**CITY OF RAYMORE**

**ADDENDUM NO. 1**

T.B. Hanna Station House Reno  
Project #19-276-204

**Addendum No. 1 - Clarification.**

**G000**

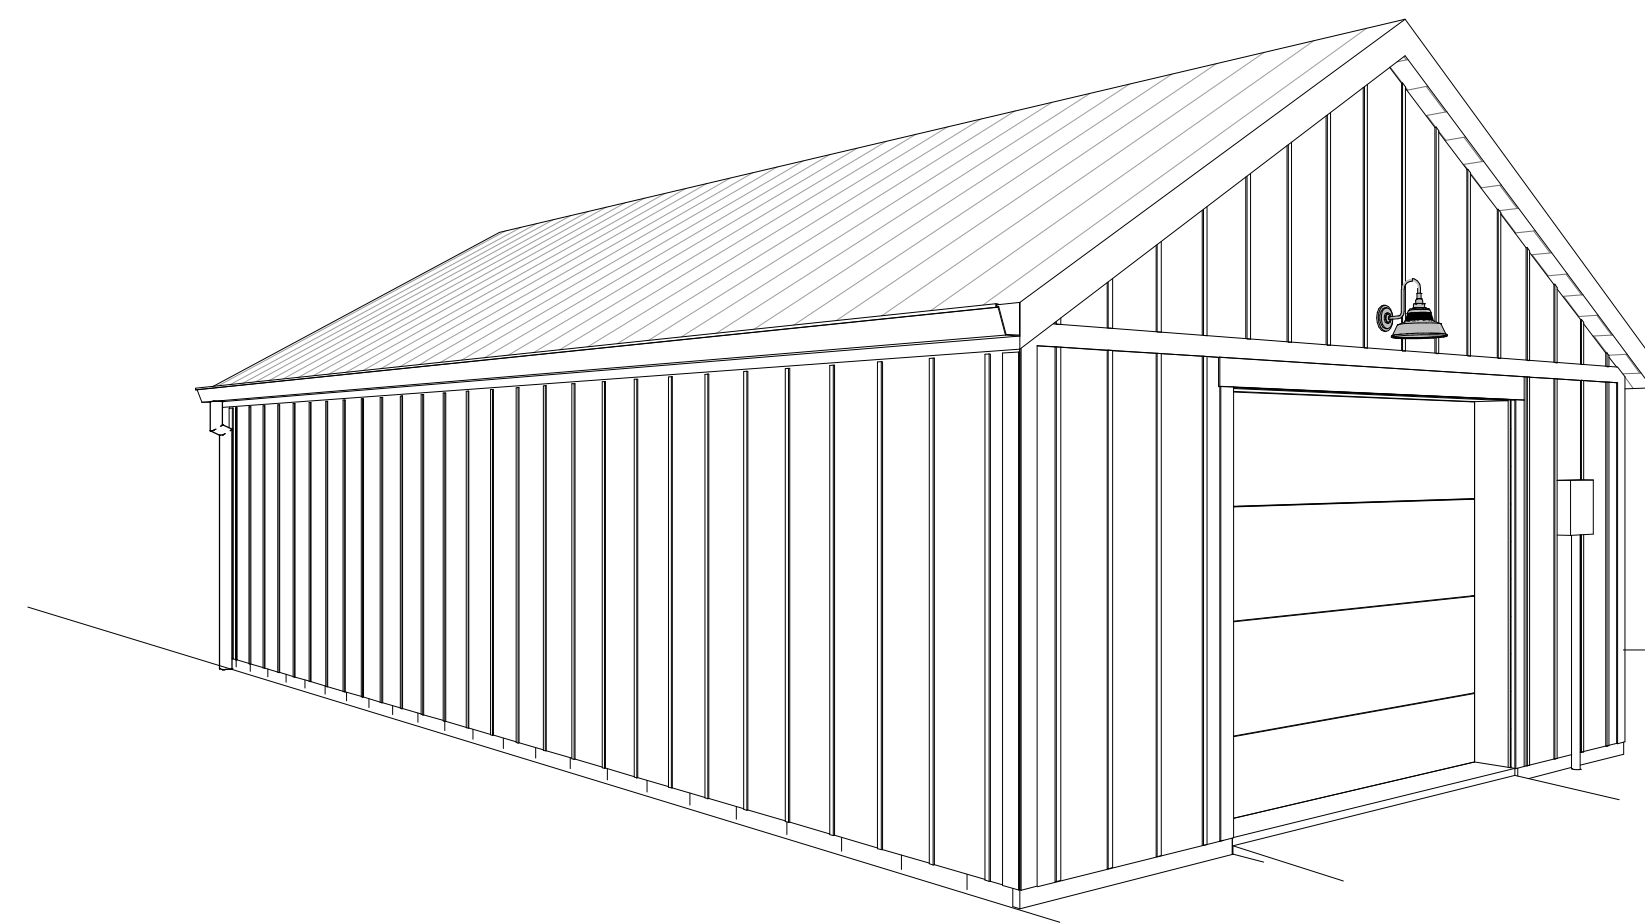
1. (Revised) Occupancy Type is S2.  
(Revised) G00 - Project Overview – Delete 'STAINING EXTERIOR DECK'  
(Revised) D100 – Note 14 – EXISTING DECK – NO WORK  
(Revised) A100 – Note 11 – EXISTING DECK – NO WORK
2. (Revised) D100 – Note 7
3. (Revised) D100 – Note 23
4. (Revised) A100 – Note 3
5. (Revised) A100 – Note 4
6. (Revised) A100 – Note 15
7. (Revised) A100 – Note 16
8. (Revised) A100 – Note 18
9. (Revised) A100 – Note 20
10. (ADD) S100 – Note 9 – INSTALL SIMPSON SDWC SCREWS BETWEEN ALL ROOF FRAMING MEMBERS (RAFTERS TO TOP PLATE AND RAFTERS TO BEAM).
11. (ADD) S100 – PROVIDE FULL SISTER OR REPLACEMENT OF DAMAGED RAFTER, IN KIND.
12. (ADD) Sheets PE001, PE002, PE100

OCCUPANCY TYPE: S2 (STORAGE) - LOW-HAZARD STORAGE
